# SPARC® Enterprise M4000/M5000 Servers Product Notes

For XCP version 1041

**SPARC Enterprise M4000/M5000 Servers Product Notes** 1

# About the interference of nut

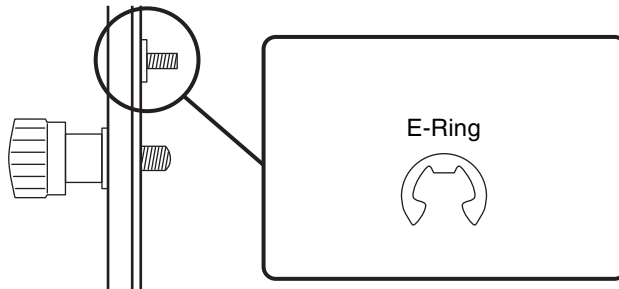
When you mount the SPARC Enterprise M4000 or M5000 server on the 19-inch rack, as you insert it all the way seated in the rack, the nut anchoring the bezel may interfere with the rack column and the server may fail to be seated correctly.

## 1. Remove the interfering bezel anchoring nut and ring.

In such a case, please replace the bezel anchoring nut and ring with the E-Ring.

2. In place of the removed nut and ring, attach the E-Ring, included in the rack mount kit.

3. Insert the server all the way seated in the rack, to lock it in place.
